# Evaluation of Water Management Measures Bayside Brunswick

R.B20133.001.00.docx  
May 2013

Prepared For: NSW Department of Planning and Infrastructure

<b>Title :</b>	Evaluation of Water Management Measures - Bayside Brunswick
<b>Author :</b>	Tony Weber
<b>Synopsis :</b>	This report outlines analyses undertaken to evaluate the water management measures proposed for the Bayside Brunswick development.

**Figure 2-1 Bayside Brunswick Modelled Flows – Pre and Post Development (without treatment)**

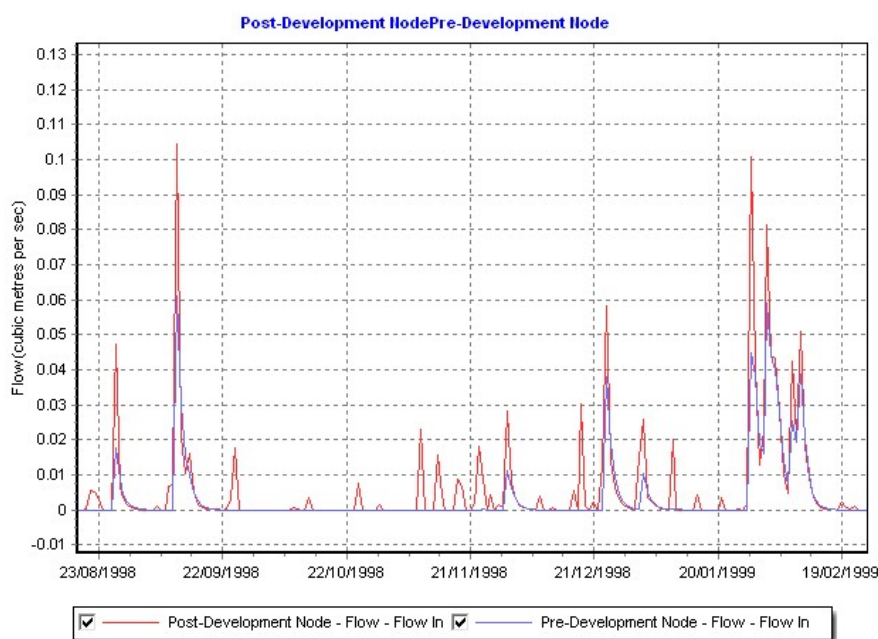
In terms of urbanisation, the two major impacts upon hydrology are increases flow volumes and in the frequency of flow events. This is best illustrated in the figure below showing daily runoff from the proposed development prior to and post development (without treatment).

As can be seen in the above graph, the red line, which indicates flows after urbanisation has occurred, shows increases in peak height and in the frequency of flow, such that there are many more runoff events compared to the blue line, which indicates flows of the undeveloped site.

**Figure 2-3 Pre and Post Development (treated) flows**

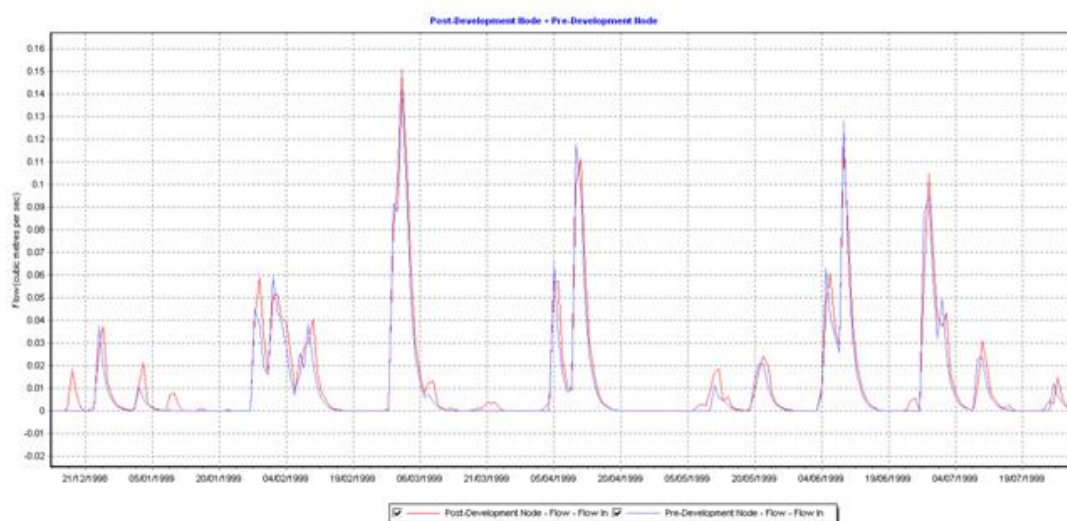
The results of the modelling are indicated in the figure below, showing how the daily flow regime has largely been preserved, with only minimal changes in flow frequency and volumes.
